PROJECT NAME : MINK_C3PO_INTEL

VERSION : A00

SSI-to EVTchange list:

EVT-to DVTchange list:

Title VGA OUT/ DEBUG PORT		
Size C	Document Number MP-00008285-004-AK	Rev A00
Date Friday, August 27, 2010	Sheet 41	of 59

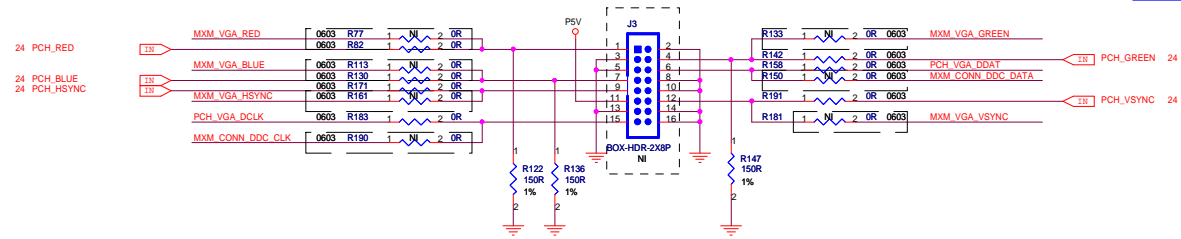
0014	SYSTEM	41	None install VGA CONN header	prevent chassis conflict with this header, (this only for debug use)
0015	CIR	43	cahnge J95 header 2P to 3P (CIR Emitter)	Prevent plug-in error
0016	SYSTEM	43	add reserve FAN (J38) for SYSTEM, but non install	For thermal request
0017	SYSTEM	44	change S3 (power button) and add LED breathing function	Meet Dell behavior SPEC
0018	Power	46	add P12V_STBY power	Fix AMP pop issue on boot and sturn off system
0019	SYSTEM	56	add PS/2 KB/MOUSE function (J31)	Dell request
0020	CPU	57	change CPU HEATSINK standoff type (M7, M8, M9, M10)	Fix the screw didn't match standoff issue
0021	SIO	42	Modify SIO_GND_Power connect to GND directly	Board can not power on cause by RSMRST#, PCIRST# can not rise 2.5V and keep normal status. Root cause is SIO GND floating
0022	SIO	42	Modify SIO_GND_Power connect to GND directly	Converter board function can not work normal, Root cause is Converter board wrong Ground net

0043	Codec	40	remove C254, C258 100uF on HP JACK	Realtek suggest
0044	Codec	40	change C321, C322 to 10uF 1206	Realtek suggest
0045	VGA	41	Add VGA debug port on EVT board	For debug smooth
0046	Chipset/ SIO	26, 45	non install R977, R918 on SIO RSMRST control and use external RSMRST control of P3V3_STB_PWRGD (non install R632, R658 and install R652(0R), R627 (499R)	Fix RSMRST power down sequence issue
0047	SIO	44	change Power button LED light color	Dell request
0048	System VR	46	change 12V(S0) enable control circuit, add Q626, R844, R846	Fix P12V_SYVS power loss issue
0049	System VR	24	Add R605 and non install	Fix RTC power loss issue
0050	System VR	32	Add R1041, C786 on P19V_CONVERTER power control	Fix PNP-MOS part DS voltage restrict issue
0051	XDP	20	Install R167 for PSOUT_SIO_N pull up RES	Fix XDP can't detect issue
0052	LVDS	24	Add COMMON CHOKE pre PCH LVDS data signal	LVDS amplitude voltage is over upper limit

0063	AMP	40	Change Audio_GND and GND applications on AMP function.	Promote the Speaker performance
0064	Audio	41	Remove D5, D6, D7, D8, D9, D10 and change to AOZ8212 solution	Promote the ESD protection
0065	AMP	43	non install Reserve FAN	For Thermo team try
0066	System VR	43	change R1833, R1834, R1835, R569, R574 from 0603 to 0805	over Dell SPEC
0067	System VR	45	Remove MAX809L and add PWRGD_PS control circuit	Add PWRGD_PS control circuit replace MAX809L
0068	System VR	56	Change DISCHARGE CIRCUIT RES Volue	over Dell SPEC
0069	Memory	19	Change DIMM conn (J3, J4) to fly type by 4/21	For thermal improvement
0070	MXM/PCH	30	change THERMITRIP_N logic circuit	Compress circuit
0071	SYSTEM	44	update power LED mode control circuit	For Dell requirement breathe function
